Road Safety Audit Report

Proposed Extension of Wychwood Green Crawley Down

Technical Note: RSA GG119 Response – Wychwood Place Extension

Technical Note: RSA GG119 Response – Wychwood Place Intensification

TITLE:
PROPOSED AMENDMENTS TO WYCHWOOD PLACE

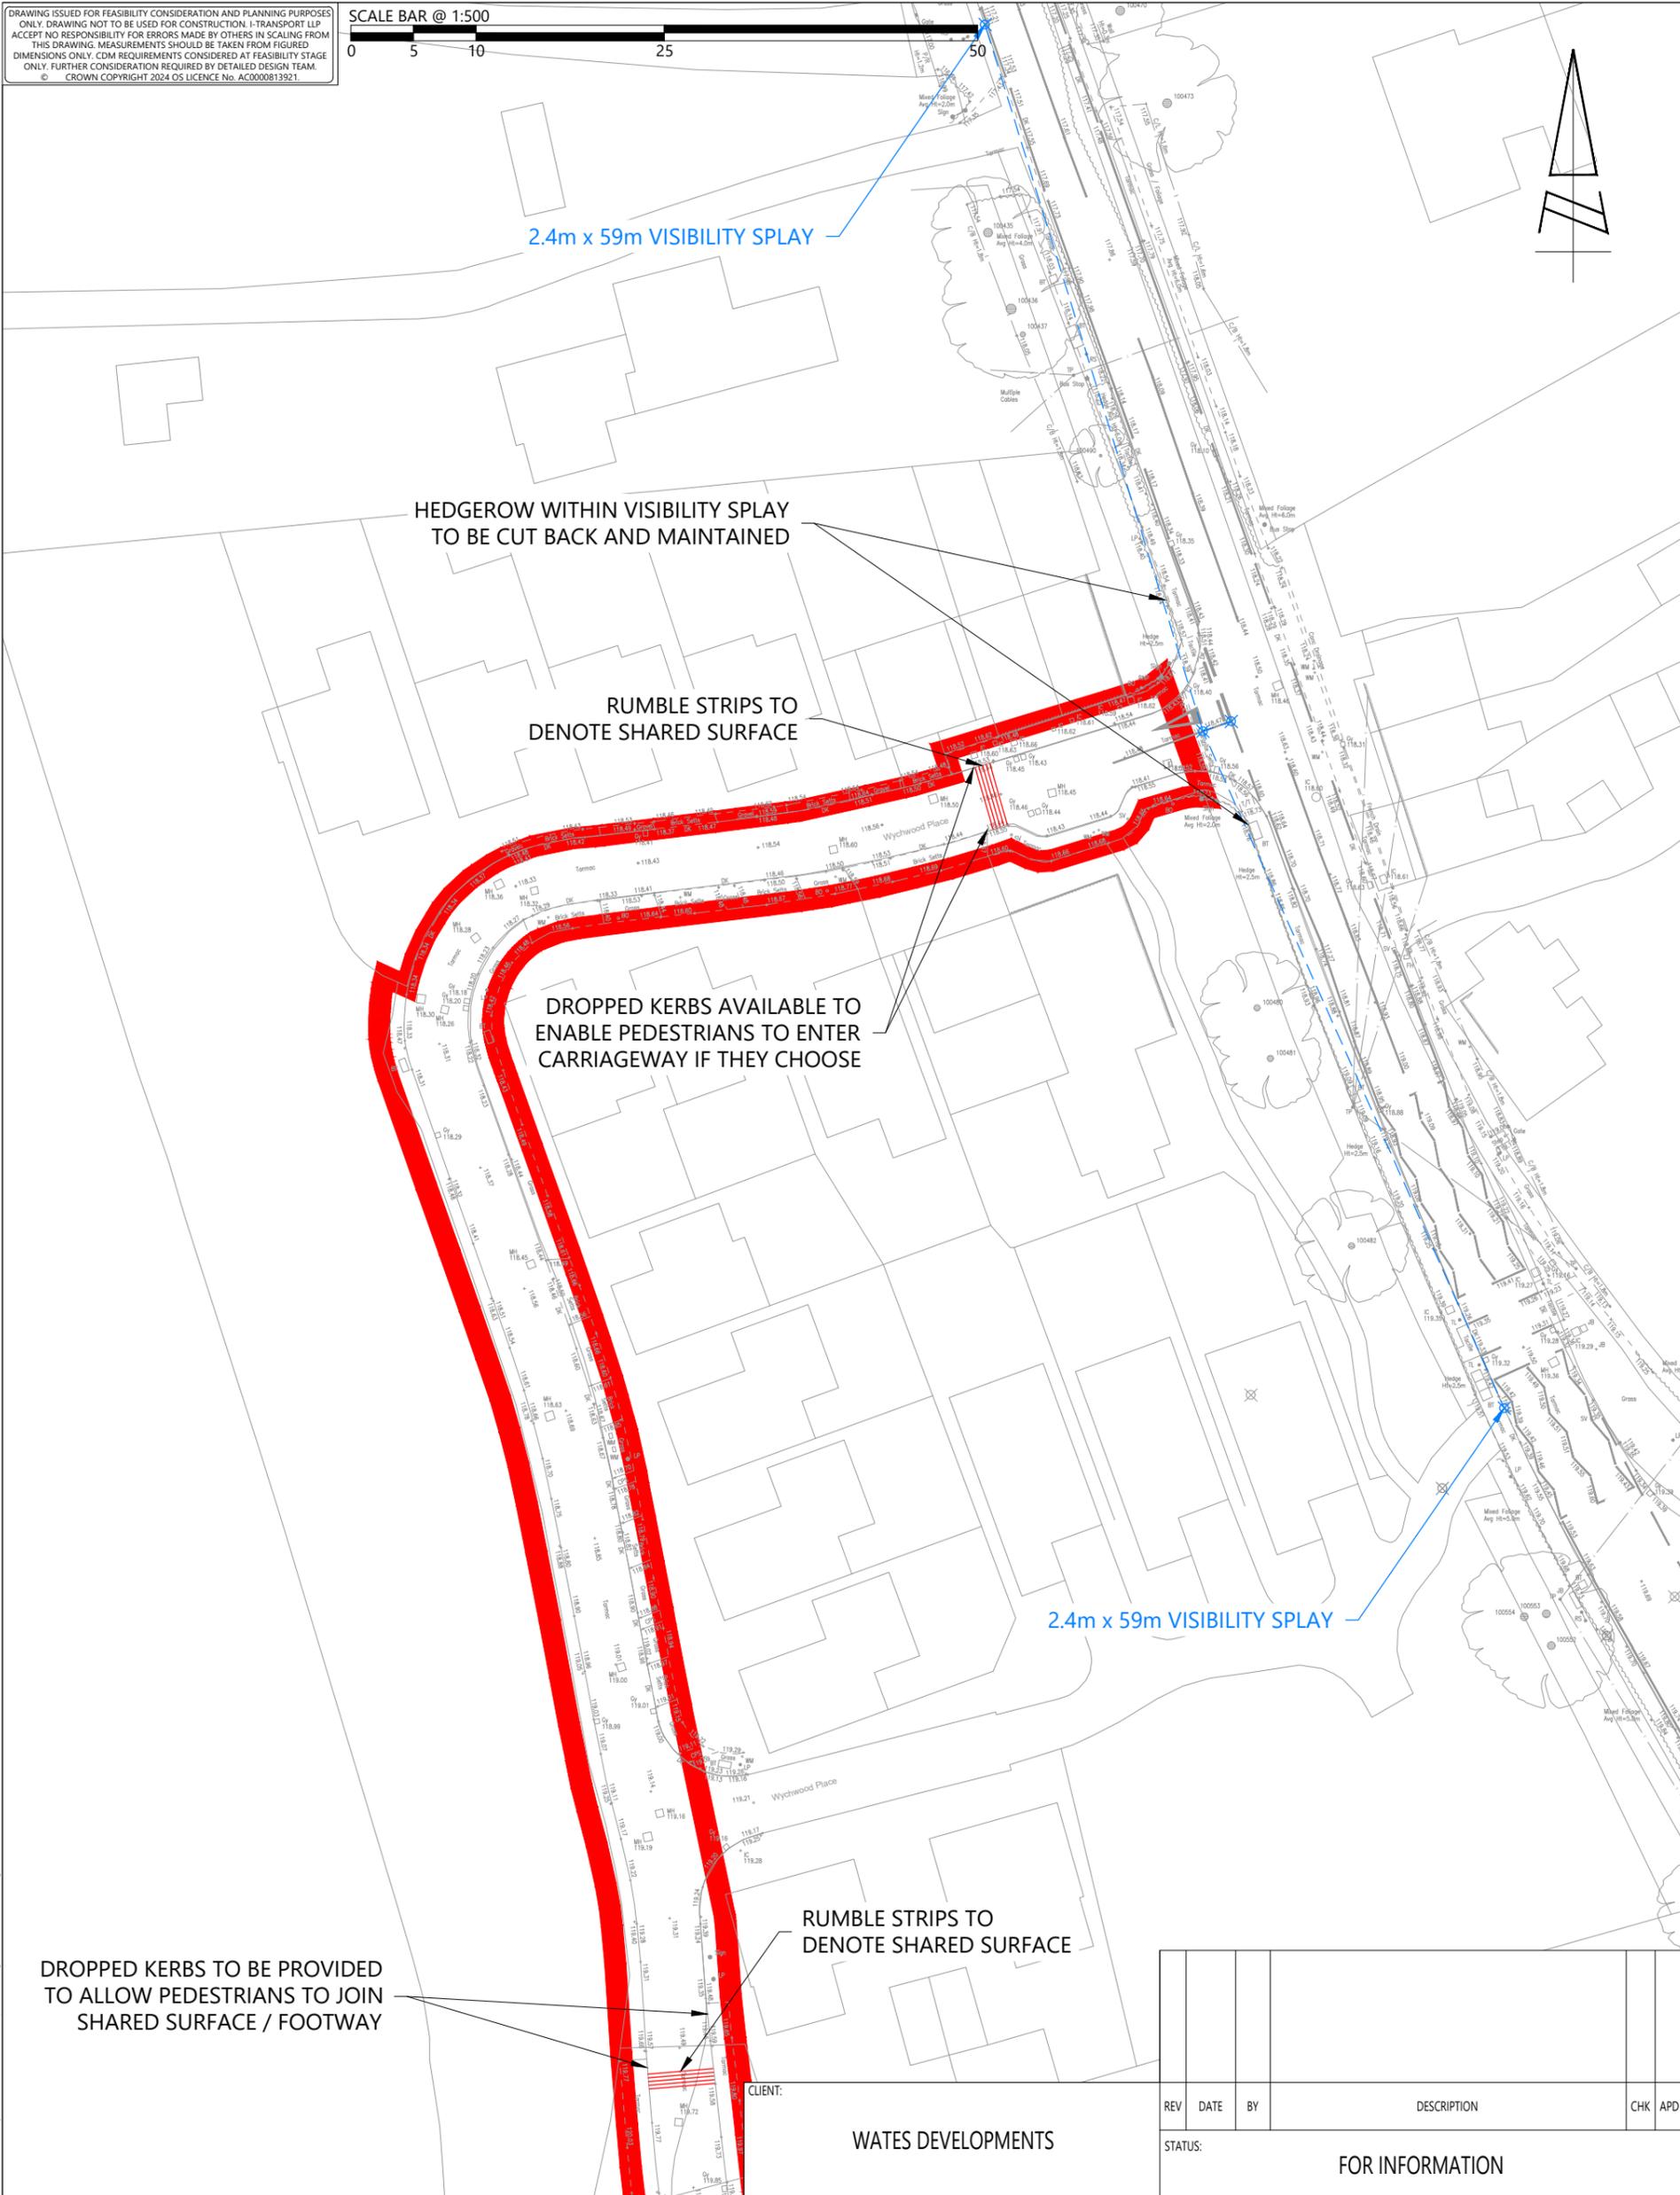
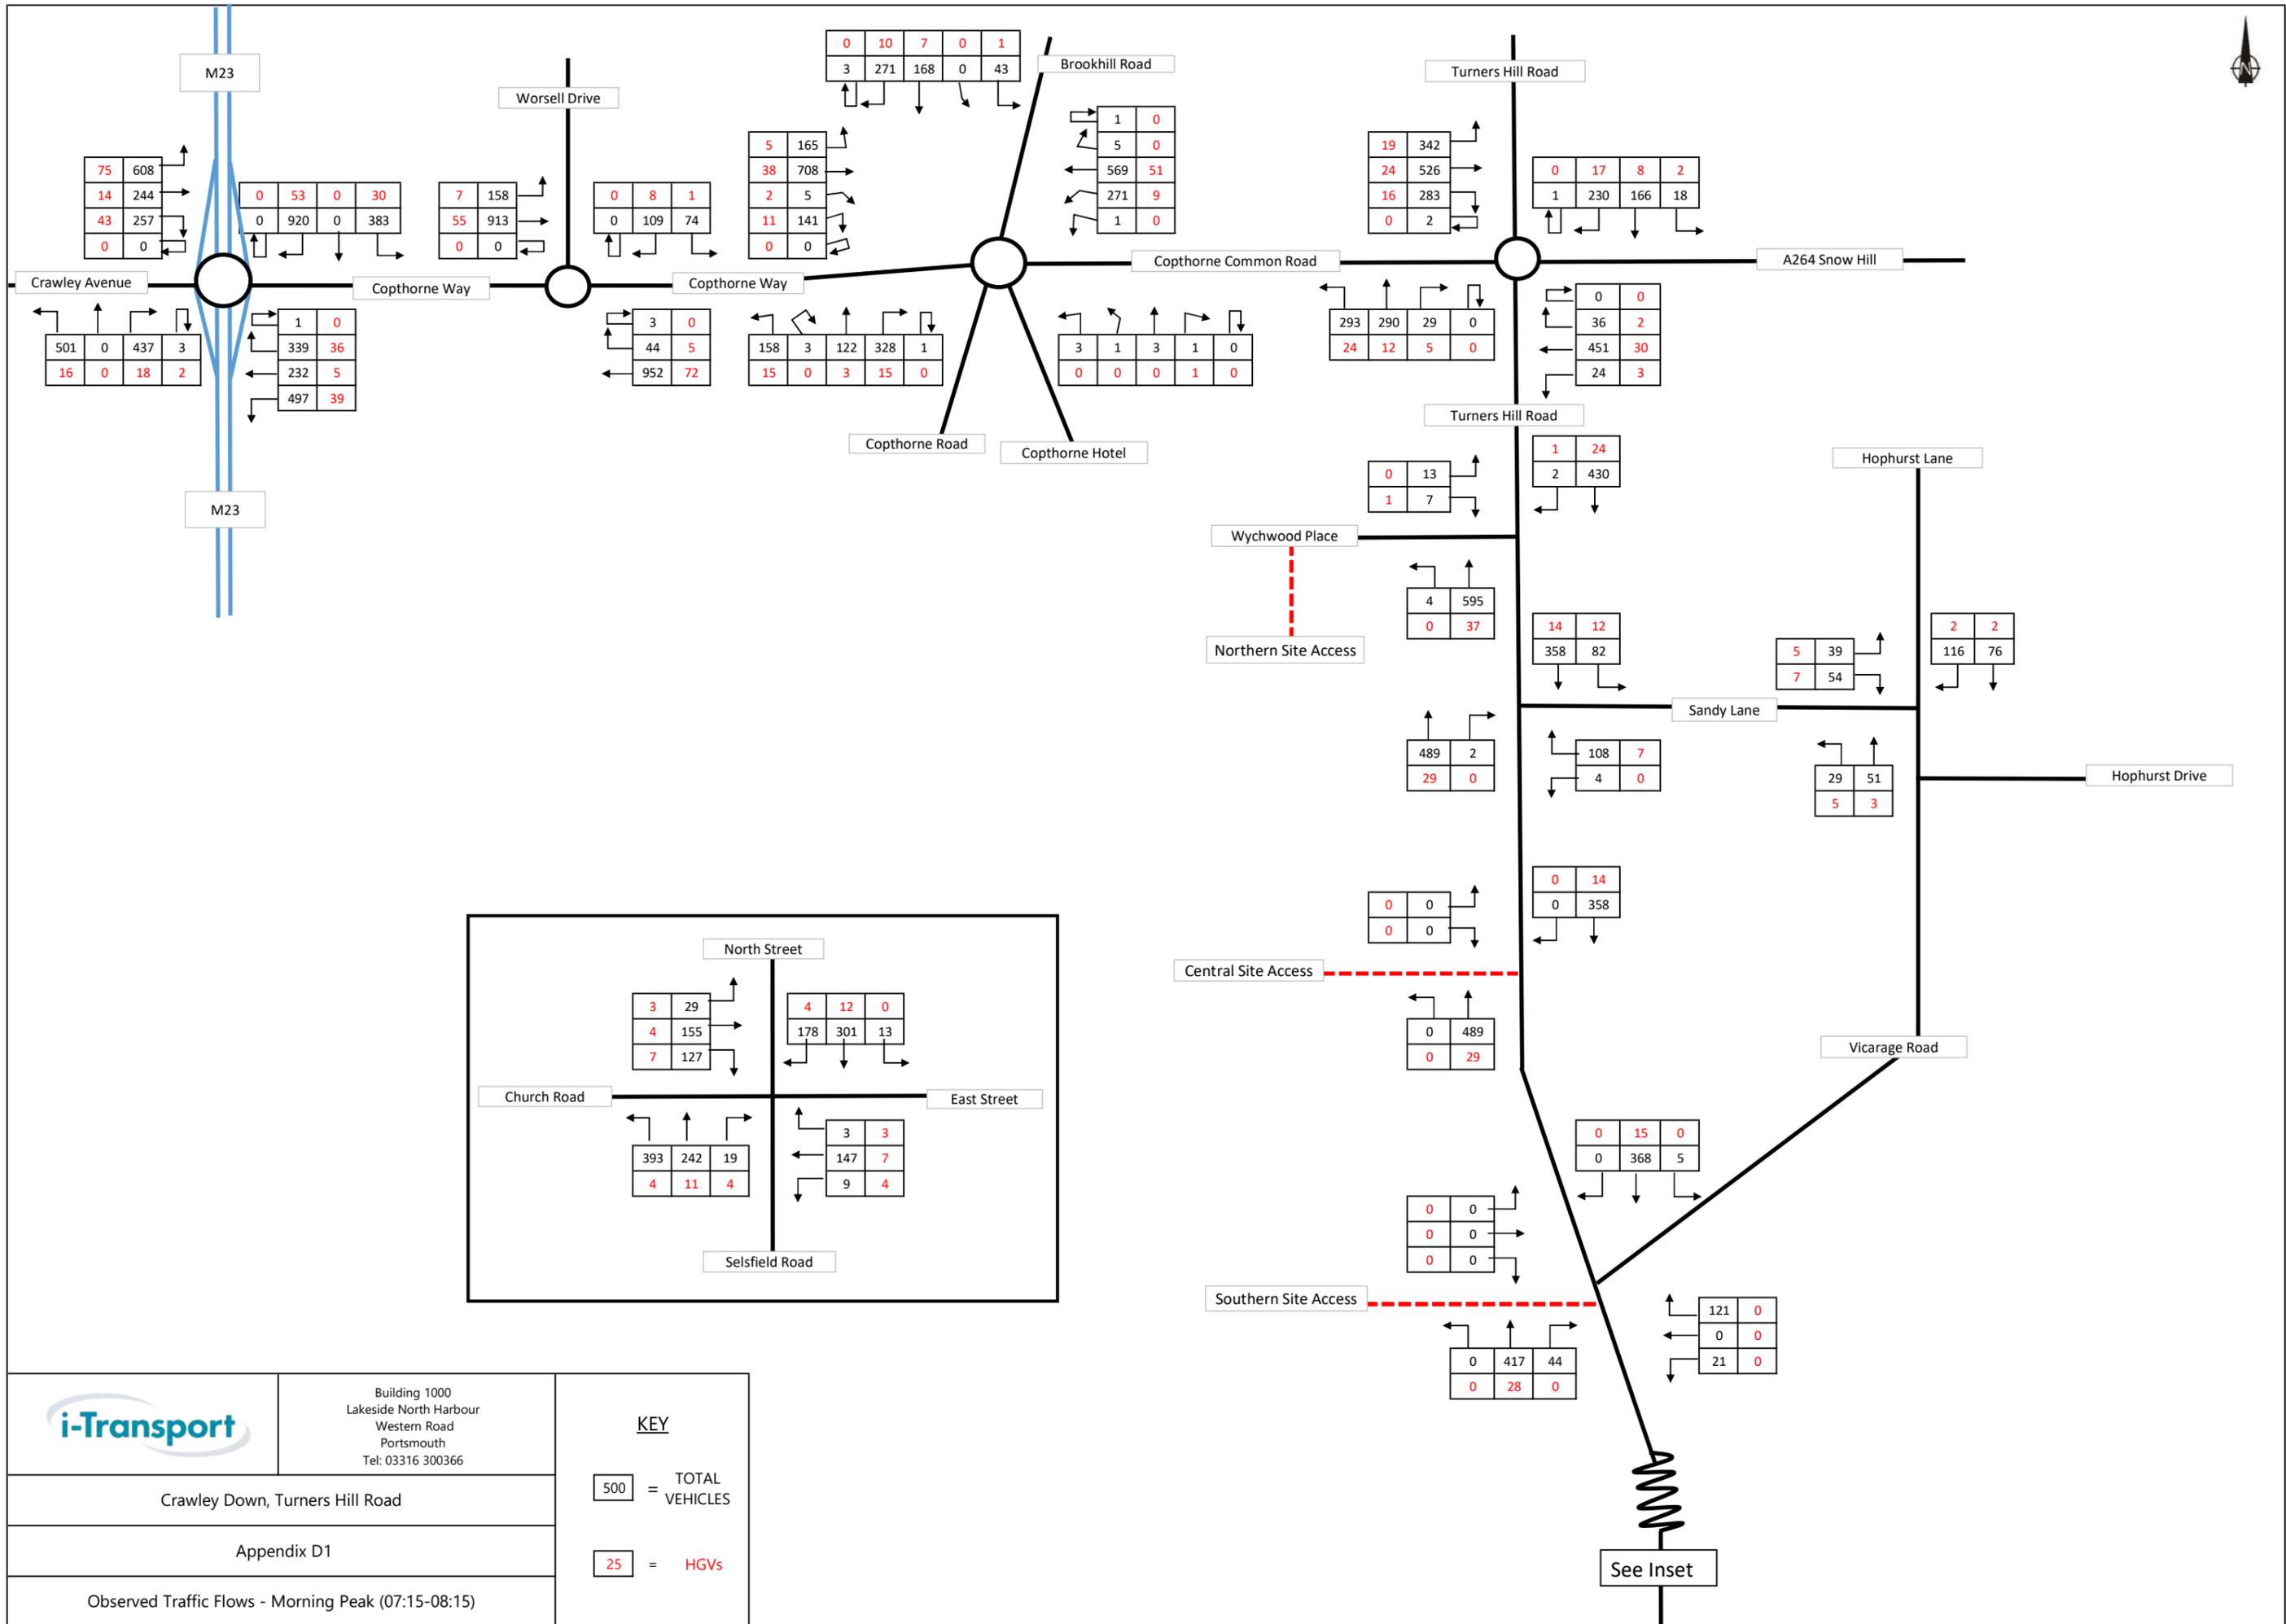
A.1	LOCAL ALIGNMENT
	<i>No Road Safety Concerns regarding LOCAL ALIGNMENT have been raised at this stage.</i>
A.2	GENERAL
A.2.1	PROBLEM
Location:	Wychwood Place
Summary:	Existing 5.5 metre wide shared surface may not allow adequate capacity
Acc Type:	Sideswipe and vehicle to pedestrian type collisions
<p>Wychwood Place is a cul-de-sac that served Phase 1 of a development that consists of 23 homes before being extended to serve Phase 2 with an additional 44 homes and observes a two-way traffic flow of circa 26 vehicular movements during each peak hours. The section of Wychwood Place within Phase 1 takes the form of a 5.5 metre wide shared surface carriageway that benefits from a circa 2 metre grass margin along one side and follows a 90° bend. That carriageway continues into Phase 2 where a footway is provided both sides of the carriageway which follows a number of bends. The proposals include the intensification of Wychwood Place to serve an additional 150 homes which is expected to generate 105 vehicular movements during the morning peak hour and 103 during the afternoon peak hour. No junction modelling has been provided to identify that the simple priority junction of Wychwood Place with Turners Hill Road, however, the flows are not considerable and therefore it is clear that the junction will operate within capacity. The section of Wychwood Place within Phase 2, which consists of a general carriageway with footways, should be adequate to accommodate the additional traffic that is expected to be generated by 150 homes, however, the Assessment Team have concerns that the existing 5.5 metre wide shared surface section are not appropriate for the expected demand, particularly when taking account of the 90° bend. It is noted that the 2.0 metre grass margin should allow for pedestrians to step off the carriageway to seek refuge, nevertheless, a shared surface carriageway that is inadequate for the expected flows could lead to sideswipe and vehicle to pedestrian type collisions. The Assessment Team note that based on the Site Layout plans included on the Planning Portal of Mid-Sussex District Council, the existing grass margin within Phase 1 should be a footway.</p>

<p>Location Plan:</p>	
A.2.2	PROBLEM
Location:	Wychwood Place
Summary:	No measures are provided to highlight the shared nature of the carriageway through Phase 1
Acc Type:	Vehicle to pedestrian type collisions
<p>The shared surface carriageway that was provided as part of Phase 1 of Wychwood Place appears to have been constructed with a general carriageway surface, albeit slightly lighter than the adjacent carriageways that benefit from footways. The proposals include an intensification in use of Wychwood Place to serve an additional 150 homes which is expected to add up to 105 vehicular movements to the route. Whilst existing, the Assessment Team have concerns that the shared surface carriageway appears the same as the adjacent general carriageway and as such, no warning is provided to motorists to highlight the change in route characteristics. Motorists not becoming aware of a transition from a carriageway to a shared surface, could continue unaware of the potential for pedestrians to be within the carriageway which could lead to vehicle to pedestrian type collisions.</p>

A.2.3	PROBLEM
Location:	Woods View
Summary:	Traffic may not proceed along the intended route
Acc Type:	Vehicle sideswipe type collisions
<p>Wychwood Place is 5.5 metres wide and benefit from a footway both sides of the carriageway with the southern footway terminating following a block of apartments where the carriageway continues as Wychwood Green. Wood View is a side road that is 5.0 metres wide and benefits from a footway along one side of the carriageway. No Road markings are provided within the existing development. The proposals include a continuation of Wychwood Green to serve a development of 150 homes. It is understood that the intended primary route for traffic accessing the proposed development is along Wychwood Place, however, a route assessment has determined that access via Woods View is shorter and more convenient than following Wychwood Place. Motorists are therefore highly likely to travel along the narrower Woods View. Whilst Woods View is 5.0 metres wide and adequate to accommodate two-way traffic, the carriageway follows two straightish carriageways that do not benefit from traffic calming, which could lead to inappropriate speeds within the existing development and sideswipe type collisions.</p>

A.3	JUNCTIONS
A.3.1	PROBLEM
Location:	Wychwood Place
Summary:	Boundary hedge limits visibility to the north at the existing priority junction
Acc Type:	Vehicle rear / side impact type collisions
<p>Wychwood Place meets Turners Hill Road at a simple priority junction. The proposals include an extension of Wychwood Place to serve an additional 150 homes. The approved plan (ITB9155-GA-001D) associated with Phase 1 of Wychwood Place, identifies that visibility splays of 2.4x57.4 metres are achievable from the priority junction which is understood to accord with observed 85th percentile approach speeds. It is noted, however, that a boundary hedge to the north limits the level of visibility. The Assessment Team have concerns that inadequate visibility at a priority access could result in a motorist or cyclist attempting to undertake a manoeuvre when it is not safe to do so, leading to rear or side impact type collisions.</p>

<p>Location Plan:</p>  	
A.4	WALKING, CYCLING AND HORSE RIDING
A.4.1	PROBLEM
Location:	Wychwood Place
Summary:	No measures are provided to allow pedestrian access between the existing footways and shared surface carriageway
Acc Type:	Vehicle to pedestrian type collisions
<p>Phase 1 of Wychwood Place is taken off Turners Hill Road and allows access to Phase 2 of Wychwood Place. The initial carriageway takes the form of a shared surface that transitions to a general carriageway that benefits from footways. It is noted that no level access is provided for pedestrians to gain access between the existing footway either side of the shared surface area. The proposals include an extension of Wychwood Place to serve an additional 150 homes. The Assessment Team have concerns that whilst existing, the full height kerb between the shared surface area and footways, are a trip hazard which could lead to falls and personal injuries. Furthermore, no tactile warning is provided to highlight the change in route characteristics to pedestrians.</p>

RSA Problem	RSA Recommendation	Design Organisation Response	Overseeing Organisation Response	Agreed RSA Action
<p>A.2.1 The section of Wychwood Place within Phase 2, which consists of a general carriageway with footways, should be adequate to accommodate the additional traffic that is expected to be generated by 150 homes, however, the Assessment Team have concerns that the existing 5.5-metre-wide shared surface section are not appropriate for the expected demand, particularly when taking into account the 90° bend. It is noted that the 2.0 metre grass margin should allow for pedestrians to step off the carriageway to seek refuge, nevertheless, a shared surface carriageway that is inadequate for the expected flows could lead to sideswipe and vehicle to pedestrian type collisions. The Assessment Team note that based on the Site Layout plans included on the planning portal of Mid Sussex District Council, the existing grass margin within Phase 1 should be a footway.</p>	<p>It is recommended that the existing margin is upgraded to a footway.</p>	<p>There are two alternative points of access - one allowing pedestrians to walk to Huntsland and one allowing pedestrians and cyclists to access Turners Hill Road adjacent to the signal-controlled crossing there. As part of the sustainable transport strategy for the site, a northward extension of the footway on Wychwood Place is proposed, as far as the shared surface that provides a connection to the pedestrian / cycle access (<i>ref: ITB9155-GA-056A in the Transport Assessment</i>). Whilst traffic flows are expected to remain under the 100vph at which MfS identifies that shared surfaces work best, it will be possible for new residents to avoid the section that has a shared surface. Residents living along the section will be able to walk in carriageway or use the verge adjacent to it if they prefer.</p>

RSA Problem	RSA Recommendation	Design Organisation Response	Overseeing Organisation Response	Agreed RSA Action
<p>A.2.2 The shared surface carriageway that was provided as part of Phase 1 of Wychwood Place appears to have been constructed with a general carriageway surface, albeit slightly lighter than the adjacent carriageways that benefit from footways. The proposals include an extension of Wychwood Green to serve an additional 150 homes that is expected to intensify the use of the existing shared surface carriageway. Whilst existing, the Assessment Team have concerns that the shared surface carriageway appears the same as the adjacent general carriageway and as such, no warning is provided to motorists to highlight the change in route characteristics. Motorists not becoming aware of a transition from a carriageway to a shared surface, could continue unaware of the potential for pedestrians to be within the carriageway which could lead to vehicle to pedestrian type collisions.</p>	<p>It is recommended that measures are provided to highlight the change in route characteristics.</p>	<p>Accepted – Drawing ITB9155-GA-064 at the rear of this note presents rumble strips to denote a share surface, as well as dropped kerbs provided (where not already available) to allow pedestrians to join shared surface / footway.</p>

RSA Problem	RSA Recommendation	Design Organisation Response	Overseeing Organisation Response	Agreed RSA Action
<p>A.2.3 Wychwood Place as well as the continuation at Wychwood Green are both 5.5 metres wide and benefit from a footway both sides of the carriageway with the southern footway terminating following a block of apartments. Wood View is a side road that is 5.0 metres wide and benefits from a footway along one side of the carriageway. No Road markings are provided within the existing development. The proposals include an extension of Wychwood Green to serve a development of 150 homes. It is understood that the intended primary route for traffic accessing the proposed development is along Wychwood Place, however, a route assessment has determined that access via Woods View is shorter and more convenient than following Wychwood Place. Motorists are therefore highly likely to travel along the narrower Woods View. Whilst Woods View is 5.0 metres wide and adequate to accommodate two-way traffic, the carriageway follows two straightish carriageways that do not benefit from traffic calming which could lead to inappropriate speeds within the existing development and sideswipe type collisions.</p>	<p>It is recommended that measures are provided to deter traffic utilising Woods View.</p>	<p>Continuing south on Wychwood Place will allow traffic to avoid turning right at the eastern end of Woods View. Continuing on Wychwood Place is therefore likely to be more convenient for most and it is expected that traffic will therefore do so. Traffic flow on Woods View is unlikely to materially change. However, the new access junction at the south west of Woods View (subject to a separate audit) will feature give way lines, making Woods View the minor arm.</p>

RSA Problem	RSA Recommendation	Design Organisation Response	Overseeing Organisation Response	Agreed RSA Action
<p>A.3.1 Wychwood Place meets Turners Hill Road at a simple priority junction. The proposals include an extension of Wychwood Place to serve an additional 150 homes. The approved plan (ITB9155-GA-001D) associated with Phase 1 of Wychwood Place, identifies that visibility splays of 2.4x57.4 metres are achievable from the priority junction which is understood to accord with 85th percentile approach speeds. It is noted, however, that a boundary hedge to the north limits the level of visibility. The Assessment Team have concerns that inadequate visibility at a priority access could result in a motorist or cyclist attempting to undertake a manoeuvre when it is not safe to do so and rear of side impact type collisions.</p>	<p>It is recommended that an adequate level of visibility is achievable at all times.</p>	<p>Accepted – as shown on Drawing ITB9155-GA-064, at the rear of this note adequate visibility splays of 2.4m x 59m can be achieved in both directions, and hedgerow within the visibility splays will be cut back and maintained.</p>
